Access Compliance Report

Public Rights-of-Way

(Curb Ramps)

Intersection ID: 10030303	Main Street: LEES_COURT_ST	Cross Street: N/A	Location: SW
ADA ID: DDBC70276389	Ramp Type: BlendTrans1	Initial Pass/Fail: Fail	Overall Compliance: No
Severity Score: 8.75			
Codes/Mitigation Info/Possible Solution		Field Measurements/Component Compliance

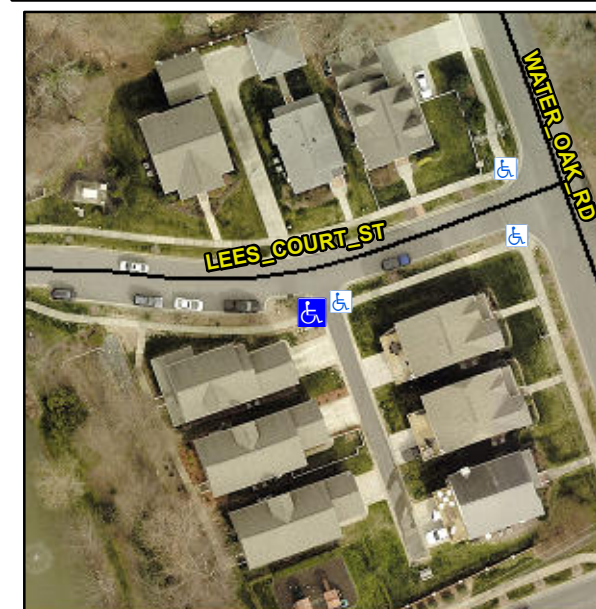
Remove & Replace Curb Ramp With Two New Directional Ramps or Equivalent.

R304.5.1
